**Release Notice**

These are software release notes for GreenStar™ 3 2630 and related products. Release Notes can be found on [www.stellarsupport.com](http://www.stellarsupport.com). Note: Your use of the software is governed by the End User License Agreement included with the software.

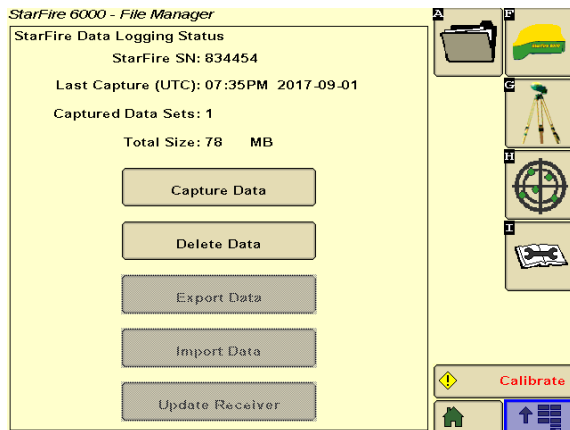
**\*Region 4 (US & Canada Only) and Region 2 Only** – John Deere Mobile RTK Signal icon has been updated
